PROPOSED REVISION 15
AP1000 DESIGN CONTROL DOCUMENT

Tier 1 Tables 2.2.1-1, 2.2.1-2, and 2.2.1-3; and Figure 2.2.1-1
Containment System

Figure 2.2.1-1
Containment System

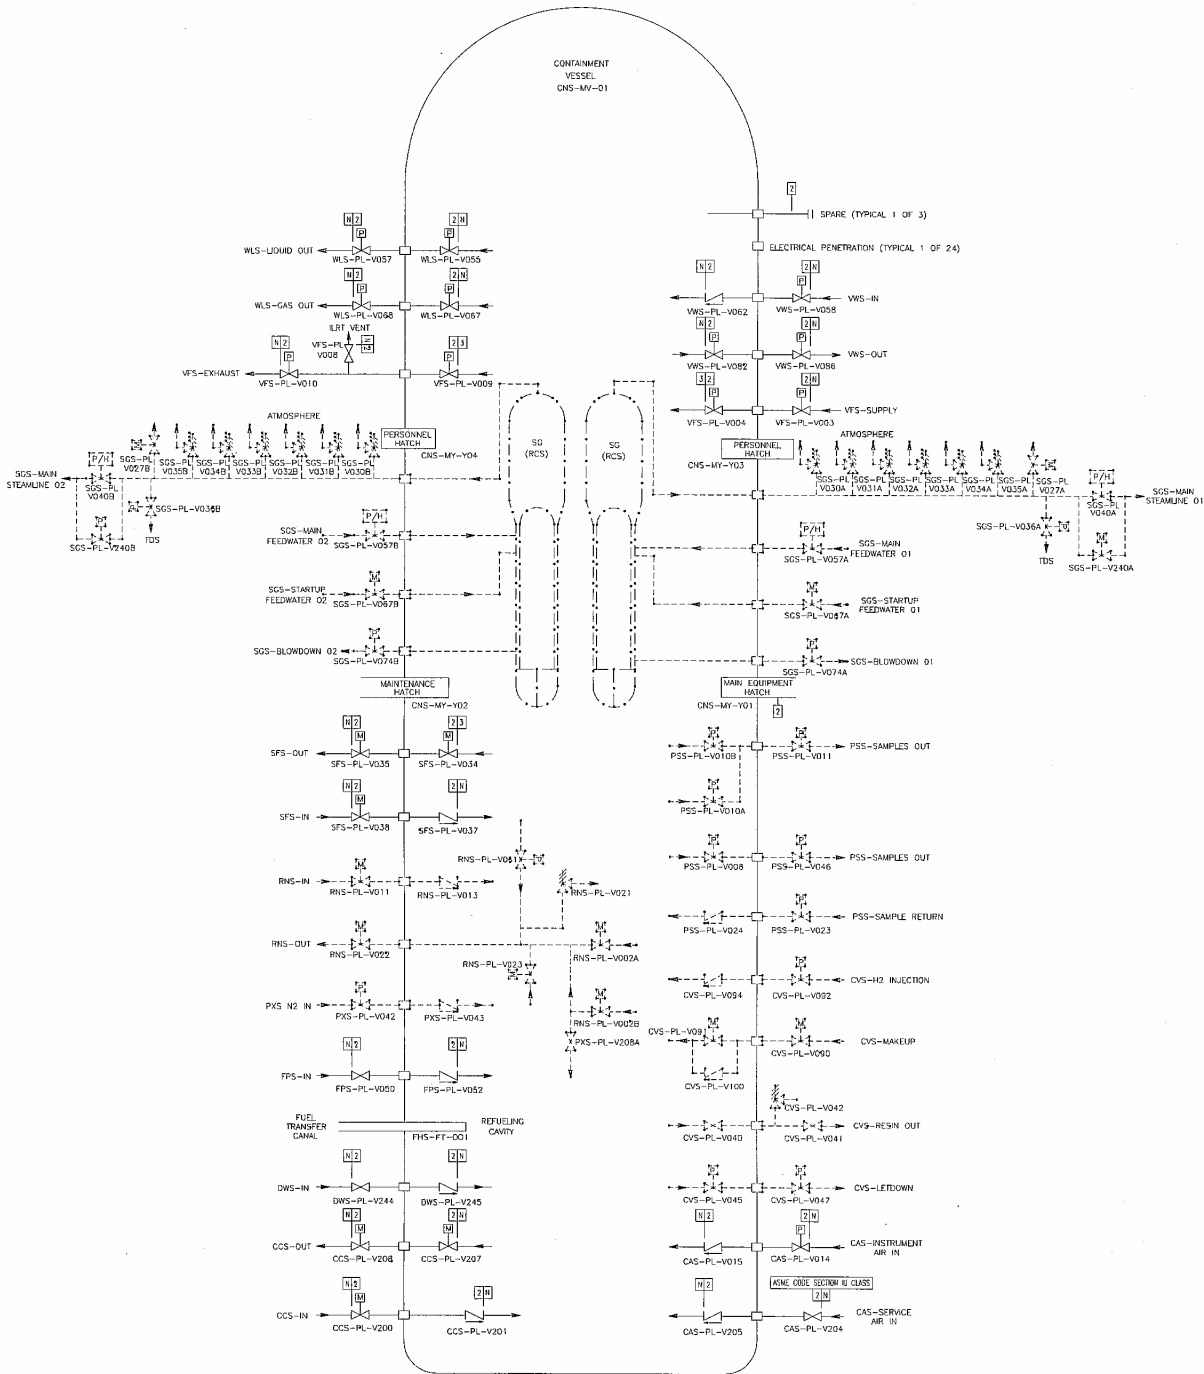
Change the tag numbers and the closure time for the containment purge isolation valves. Also provide a precise reference for ITAAC item 6.c in Tier 1 Table 2.2.1-3.

Tier 1 Figure 2.2.1-1 Revise Tier 1 Figure 2.2.1-1 as follows:
